13 December 2012

SSD-5346, SSD-5347, SSD-5349 - Stages 2B, 2C & 2D, and 3B of the North Penrith Mixed **Use Development**

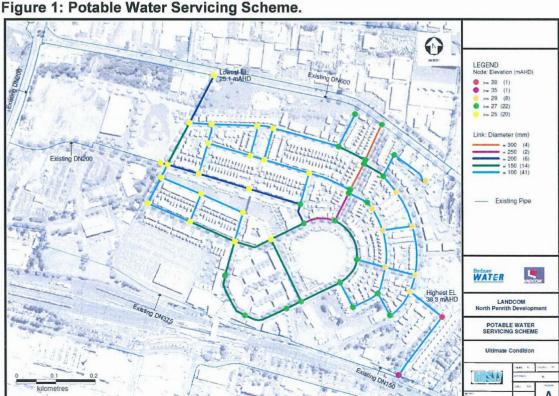
The proposed lots will be served by a water main extensions off the drinking water mains constructed in Stage 1.3 of the North Penrith Development. All the drinking water mains for the proposed subdivision, will be sized according to the drinking water layout shown in Figure 1.
